**Freedom of Information request reference number:** 8570.1

*This request relates to a development at Townsend Yard, Highgate, London N6 5JF. It follows on a previous request (FOIA 7437.1) made on 24 April 2023 by the Highgate Society, to which you responded, thank you. The Highgate Society now makes a further FOIA request to see:*

**Ref: Non-Material Amendment to planning permission HGY/2020/1326 to alter design and layout of Unit 1 to incorporate fire brigade access through an alleyway at ground floor level. Our ref: 31/164103.**

Following the Highgate Society’s earlier objection, it is now writing to object to the revised Fire Strategy Report Rev 2 (FSR2) submitted in January 2024 (but dated July 2023) in support of application HGY/2023/2493. While FSR2 primarily deals with fire safety and general fire strategy for the mews, it also addresses the fire safety strategy for the Shepherd’s Cottage (36a Highgate High Street) but does so only briefly under clause 10.7 of the report. This leaves the Society very concerned for the safety of the Cottage and its occupants. The areas of concern are:

Figure 8 - Fire Tender Swept Path Assessment

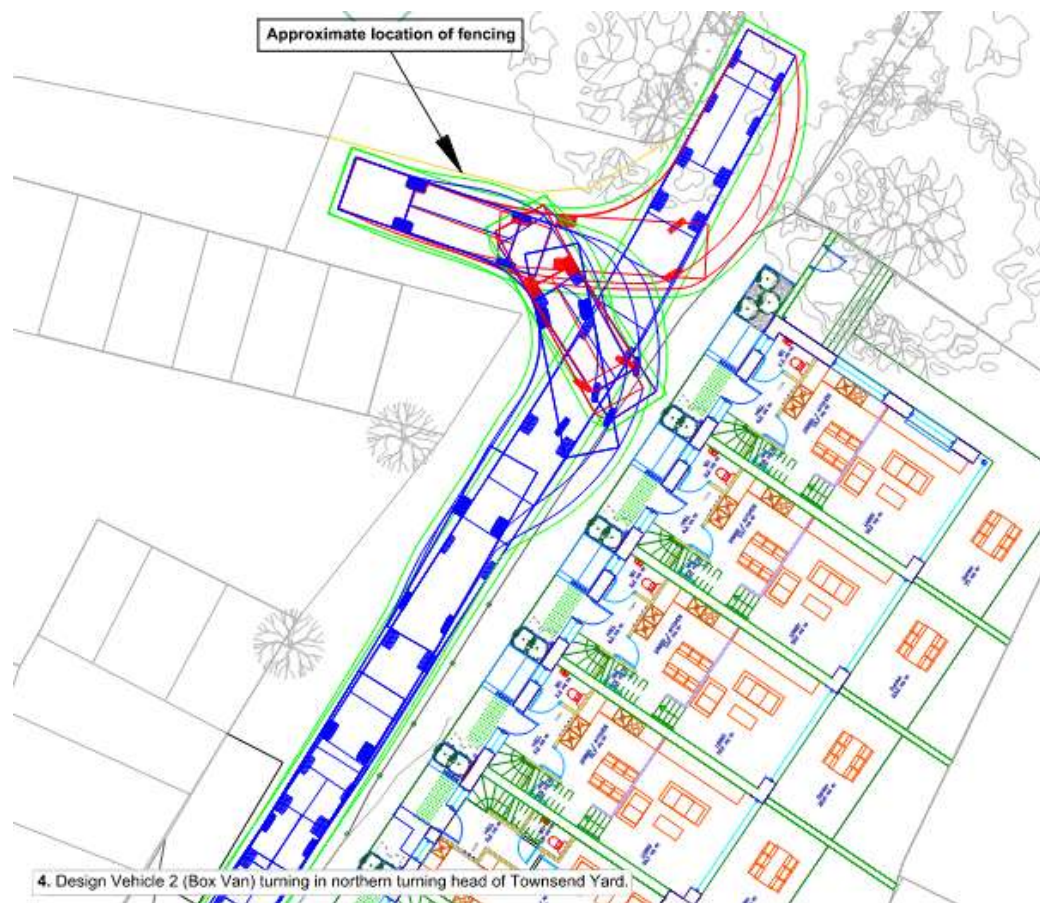
- a. Option 1 - The fire engine will drive down the lane and turn on private land  
 The swept path assessment provided in the report does not show that vehicles are normally parked in the narrow High Street opposite the lane which means the fire engine does not have enough turning space in Highgate High Street to enter Townsend Yard either backwards or forwards.  
 Furthermore while the fire service has the right to pass over private land, the land owner (Omved) has the right to put up a permanent barrier which would block a fire engine from turning. A turning head that requires access to private land, over which the applicant has no control and which could be redeveloped in the future, is not a suitable solution to meet ADB5. Unless the applicant is able to put in place an agreement with Omved under the terms of which Omved rescinds the right to put up a permanent barrier this cannot be considered a viable option. If the developer intends to pursue this option the agreement must be put in place before approval for further construction takes place.

Figure 11 – Fire brigade access to the cottage via alleyway

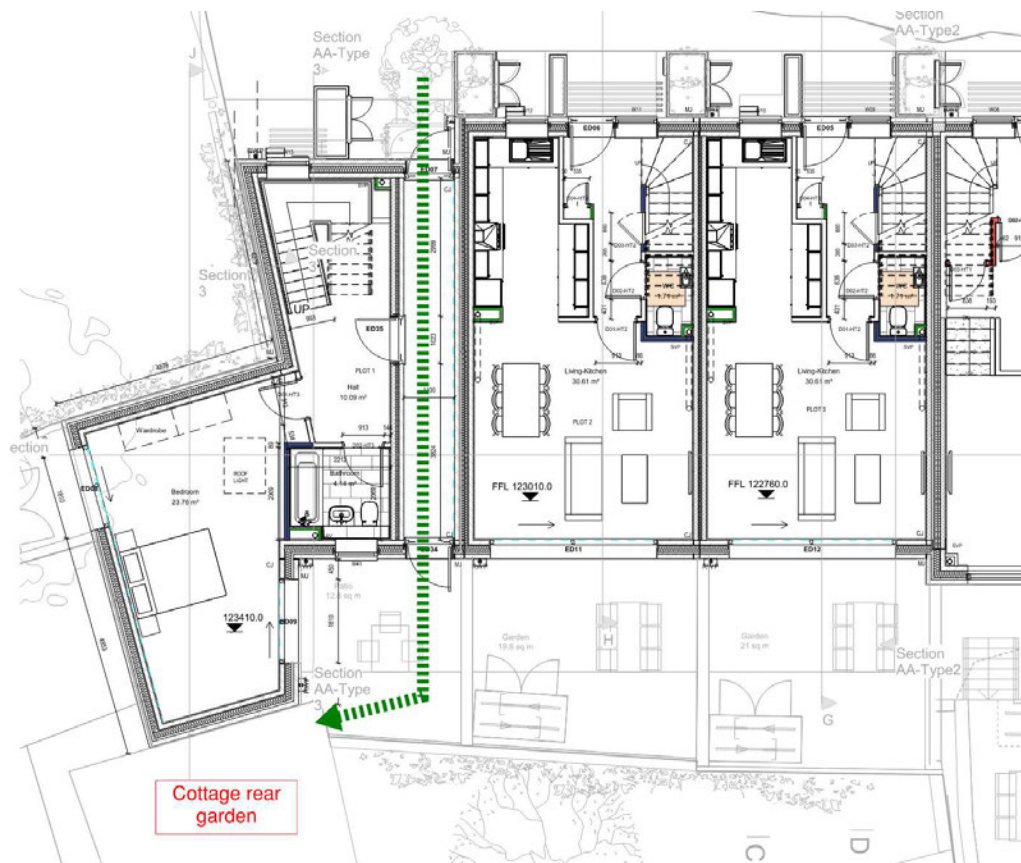
3. It is essential that there is unhindered access to the rear of the property and we note that, under Clause 10.7 of FSR2 it is proposed that an alleyway be formed through House 1 to give the LFB access to the rear of the Cottage. However, there are serious flaws in the design of this route as follows: Please note that most of the drawings submitted with this report fail to show the alleyway and there are no levels, or details of heights of walls within the submitted material.

5. Furthermore Figure 11 on pg 23 of the FSR2 is not correct. It locates the “cottage rear garden” where the Cottage is so the arrow in the diagram which is supposed to show the route for firefighters directs them straight into the Cottage wall!

However an alleyway will be provided in the first dwelling to allow the passage of fire brigade personnel to the rear of the cottage. The alleyway will be gated, it will be accessible by fire brigade using fire brigade key. The deed of the dwelling which host the alleyway will state that the alleyway need to be left clear at all time.

Project: Townsend Yard  
Title: Fire Safety Mark-ups Ground Plan  
Revision: Issue 2.0      Scale: 1:60 @ A1  
Prepared by: [Signature]      Date: 21/07/23  
Checked by: [Signature]      Date: 21/07/23

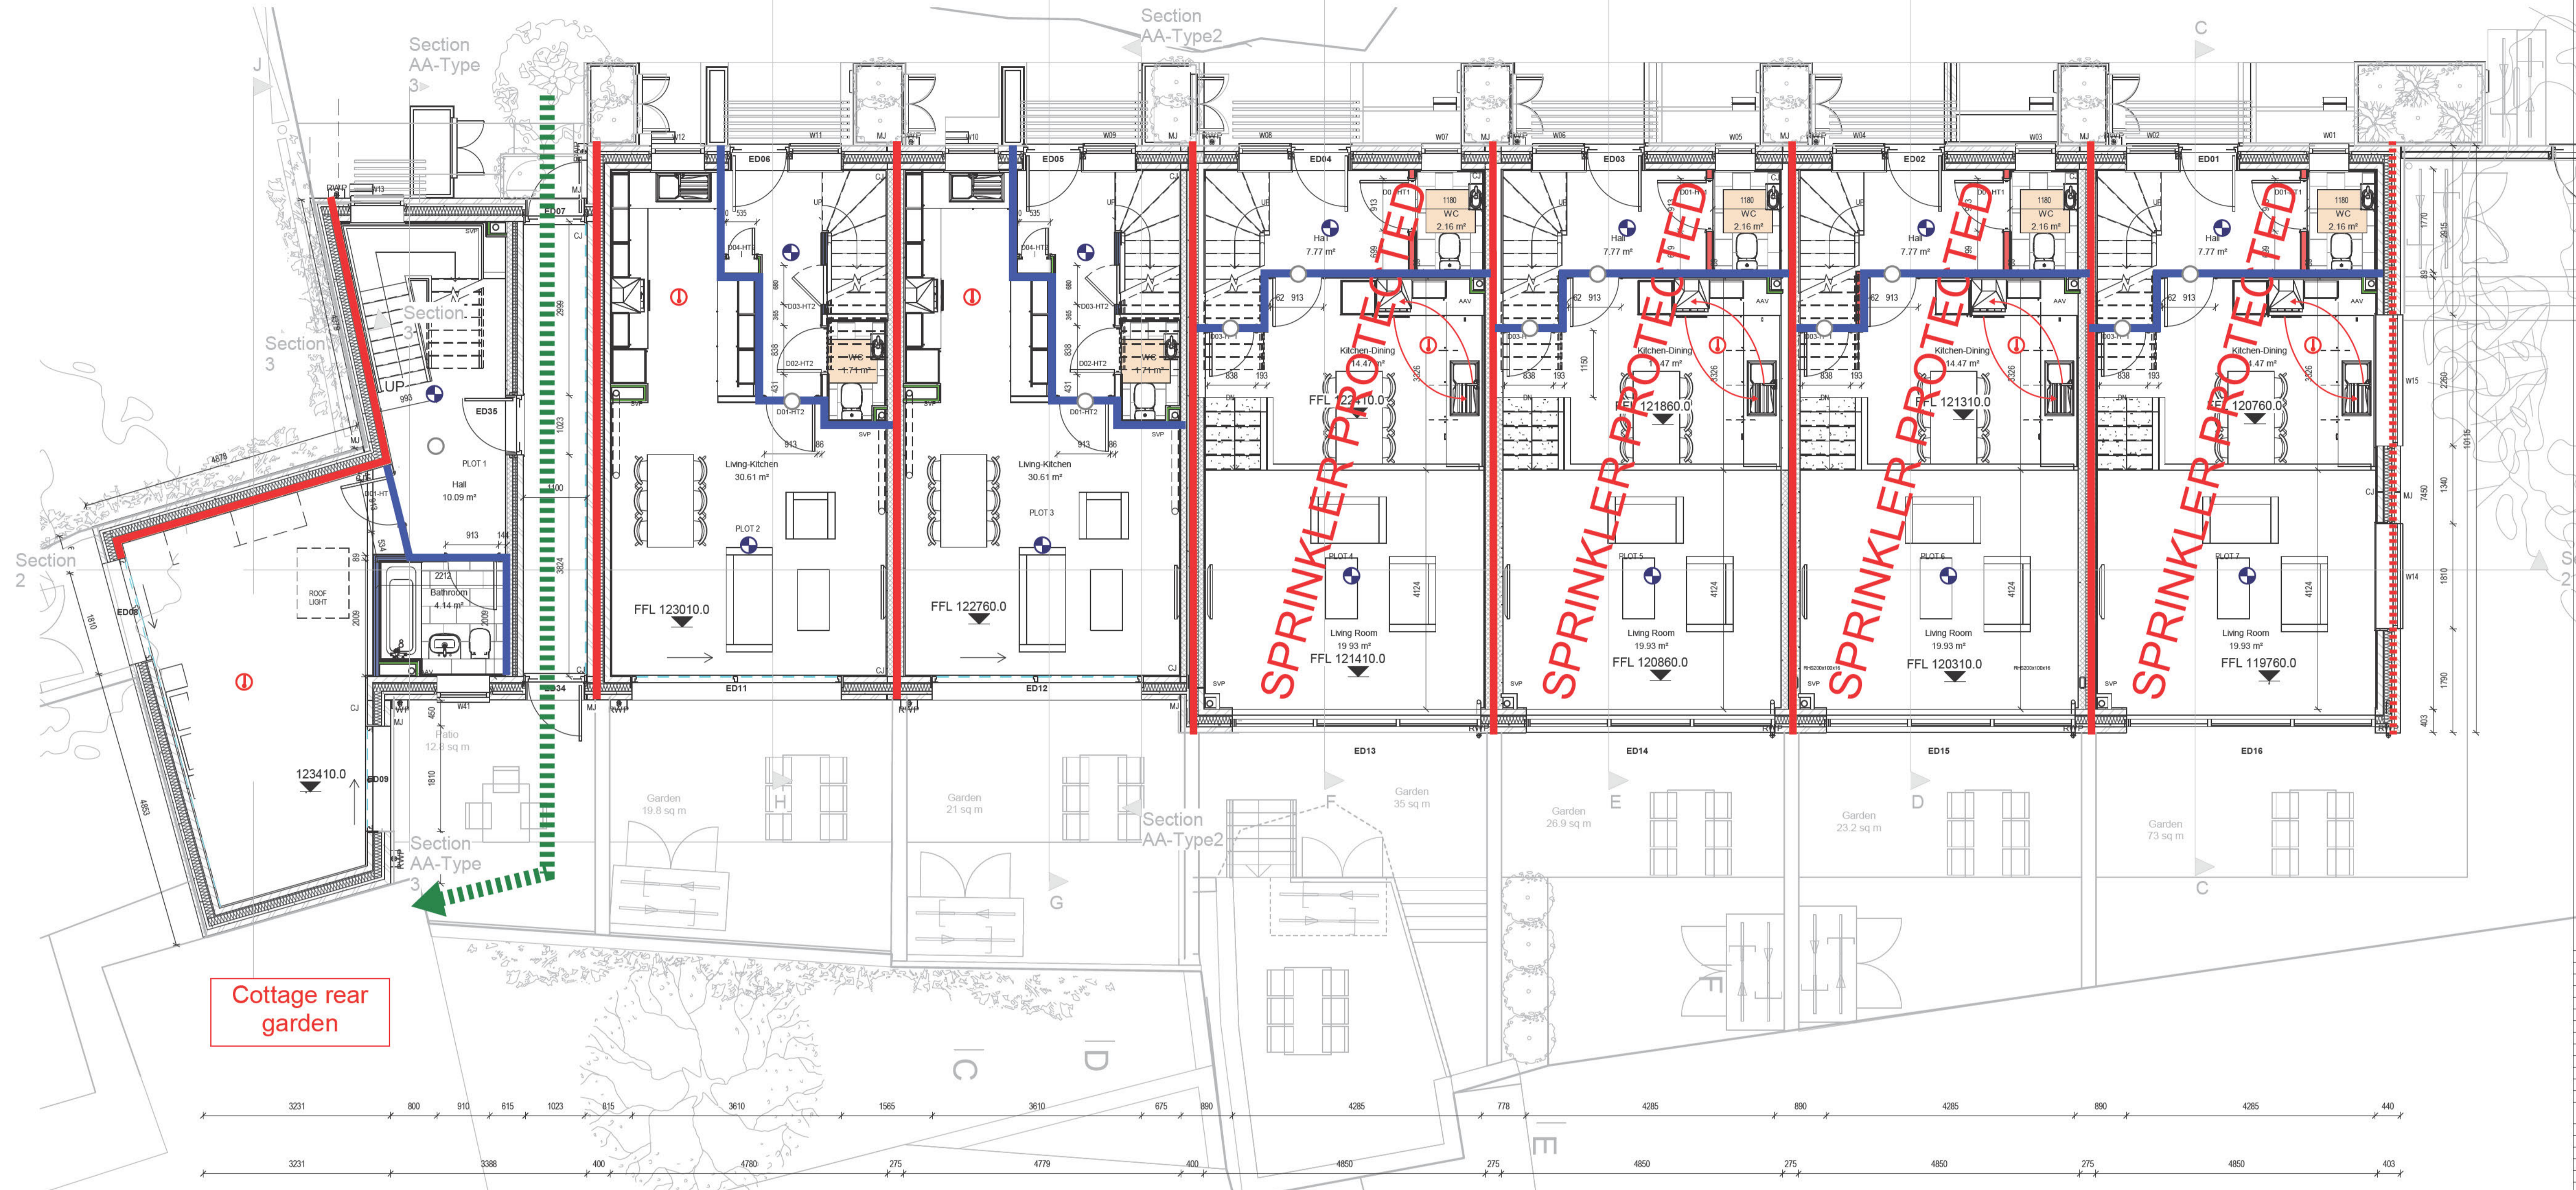
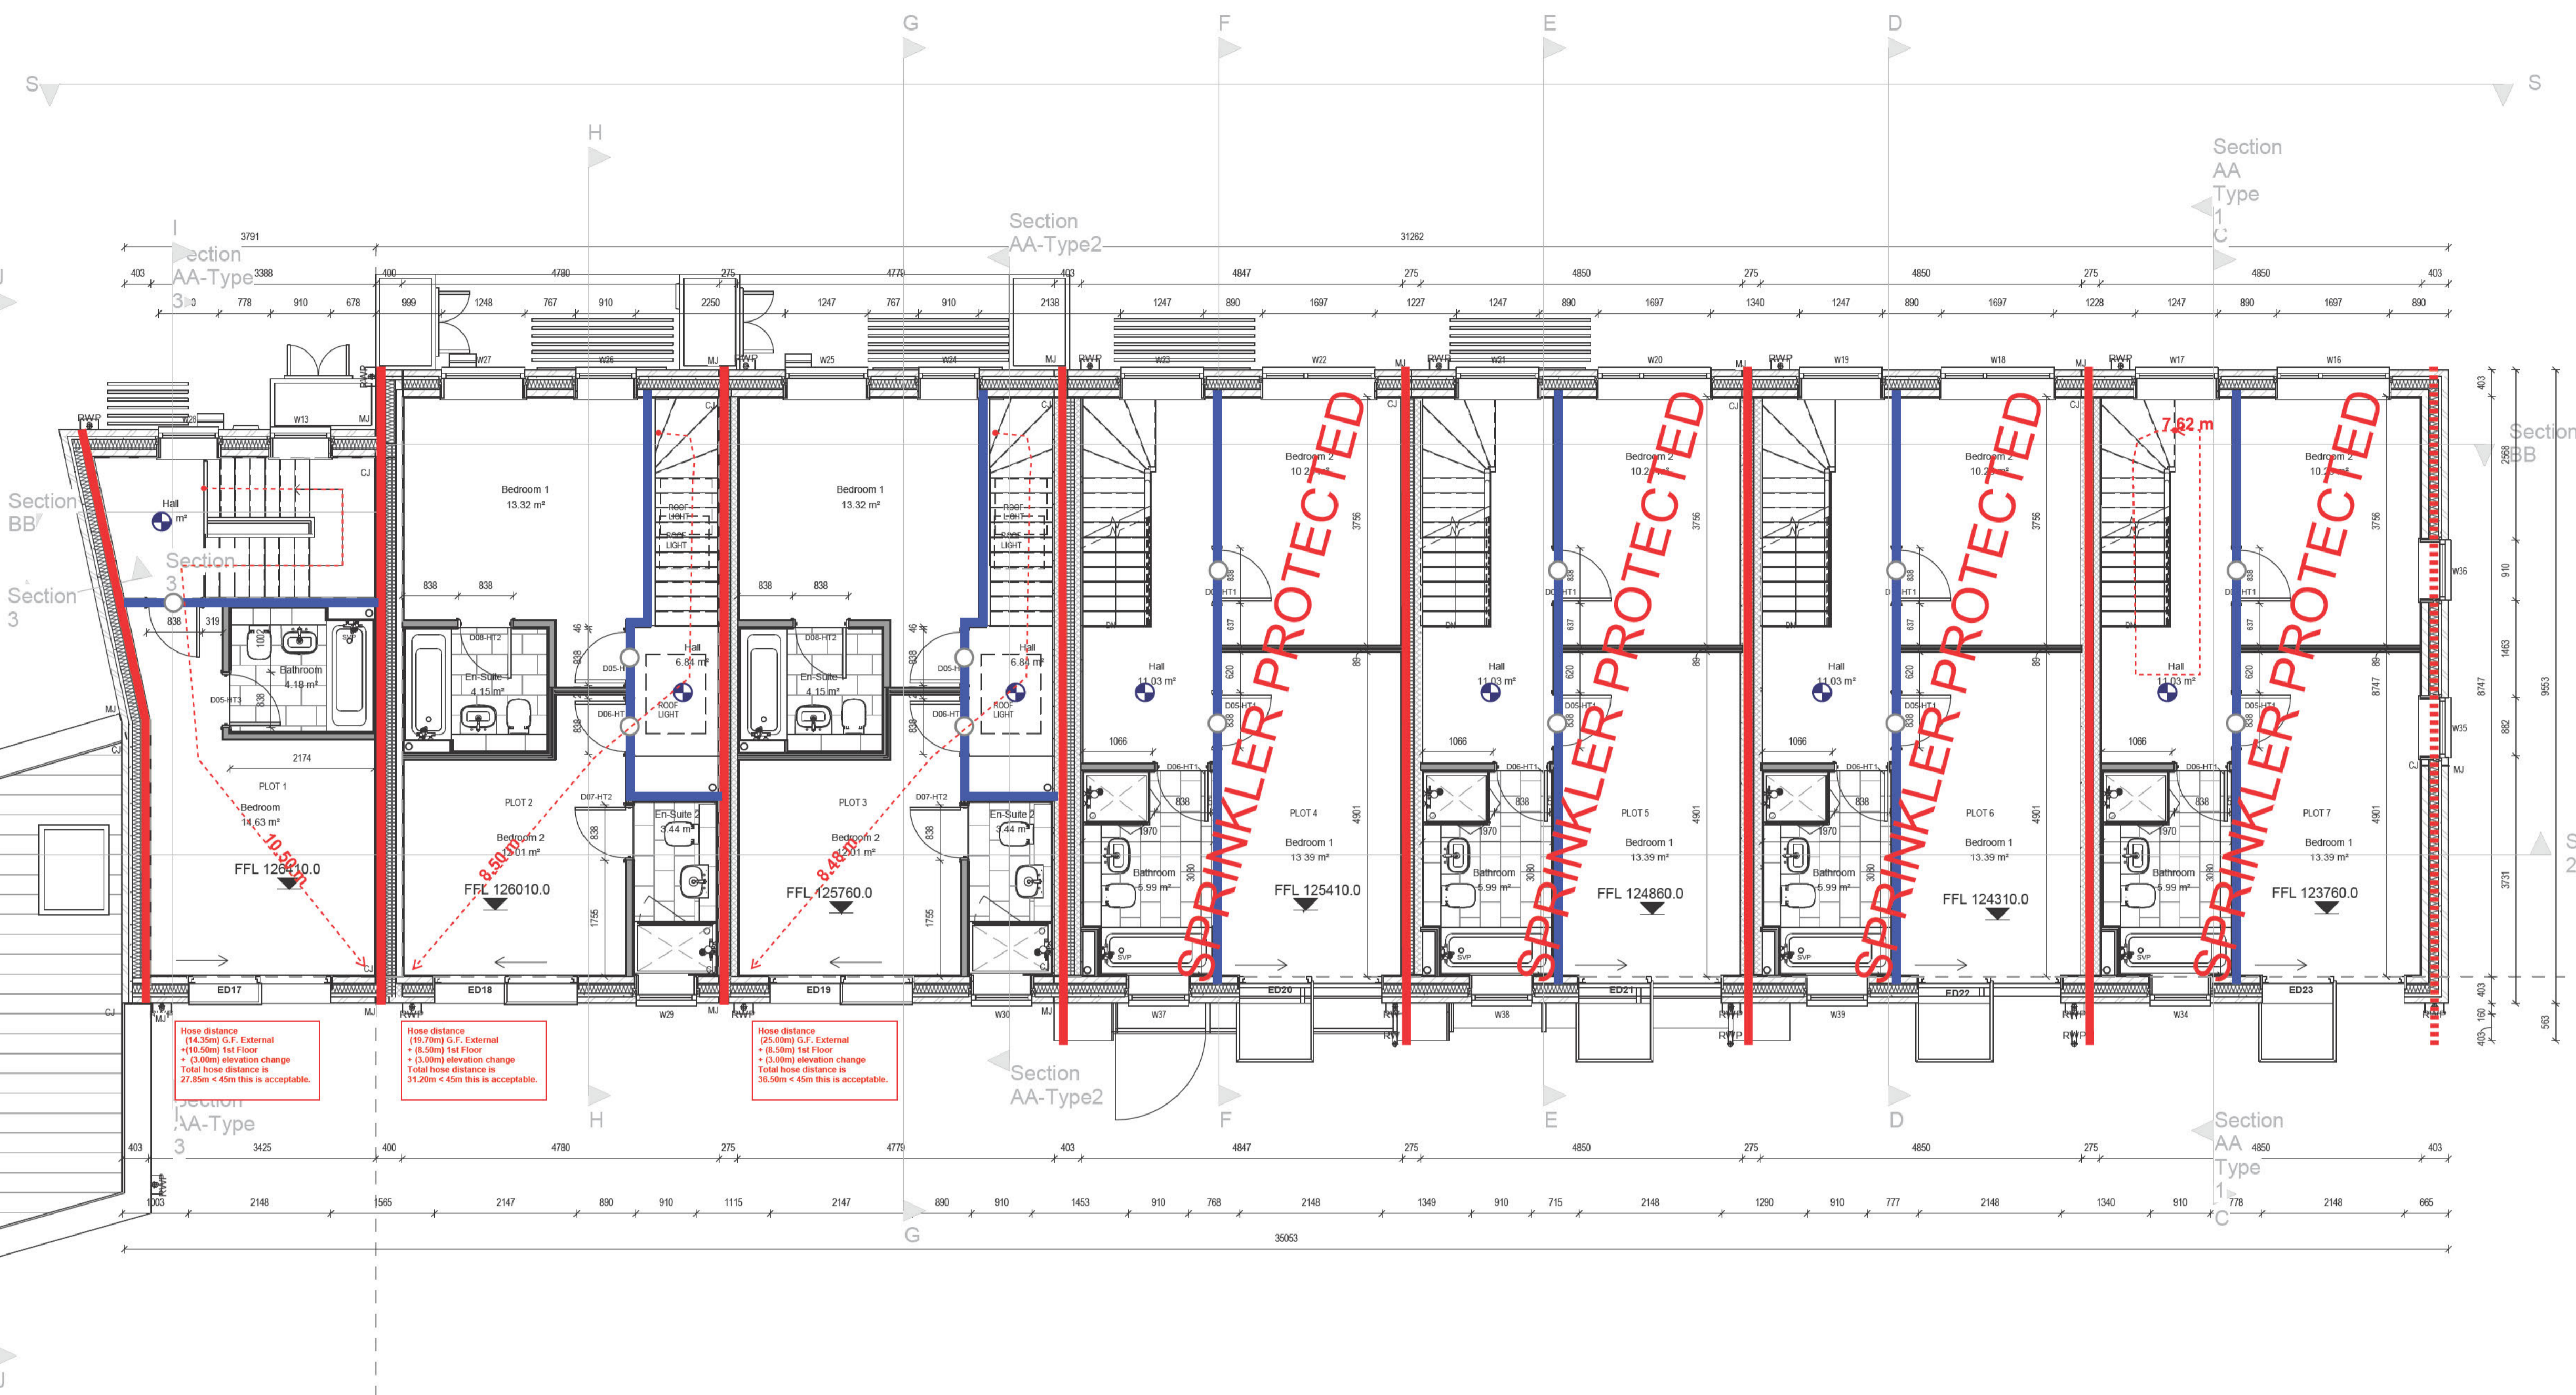
Hose distance (14.30m) G.F. External + (10.50m) 1st Floor + (3.00m) elevation change  
Total hose distance is 27.80m < 45m this is acceptable.

Hose distance (19.70m) G.F. External + (8.50m) 1st Floor + (3.00m) elevation change  
Total hose distance is 31.20m < 45m this is acceptable.

Hose distance (25.00m) G.F. External + (8.50m) 1st Floor + (3.00m) elevation change  
Total hose distance is 36.50m < 45m this is acceptable.

Scenario 1 – A fire breaks out in the High Street buildings cutting off the passageway to the High Street.

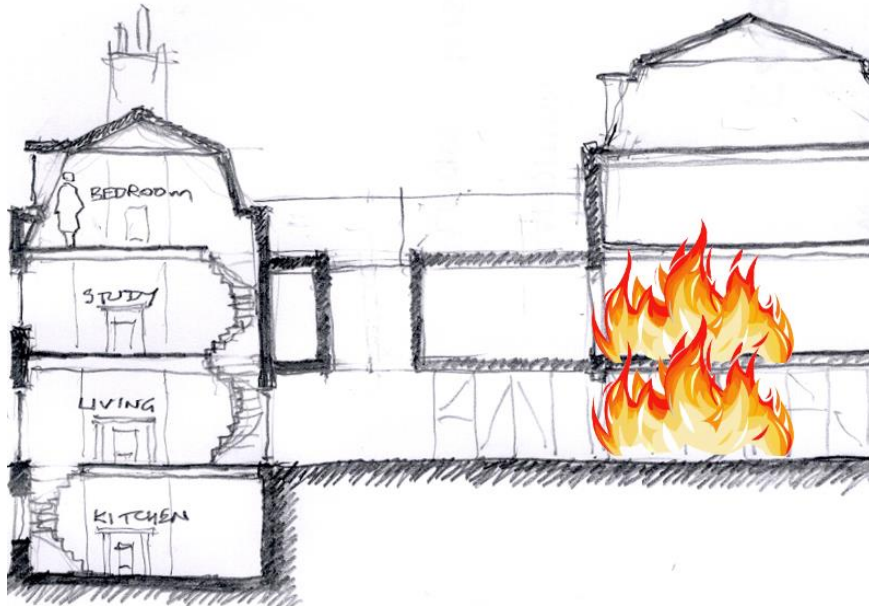
With the wind tunnel effect through the passageway the fire could quickly spread back towards the cottage.

Scenario 2 – A fire breaks out on the lower floors of the cottage.

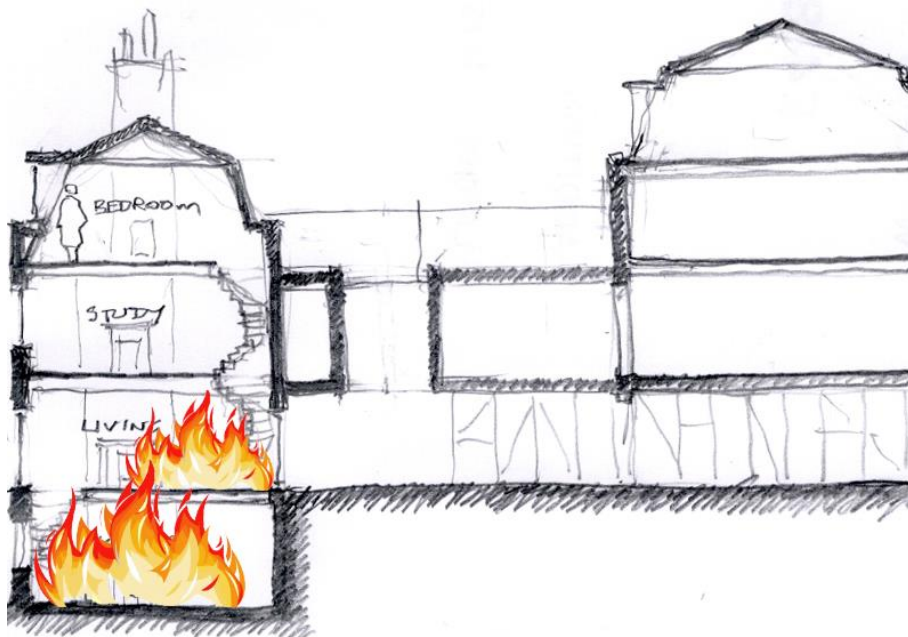
Bear in mind that the cottage is timber framed with no fire separation between floors, open stairs and just floorboards on exposed timber joists. There are open fireplaces on each floor. If a fire were to break out on the lower floors it would quickly engulf the whole house so escape from the bedroom which is on the top floor would have to be through a window and the windows are only on the north side of the cottage facing Townsend Yard.
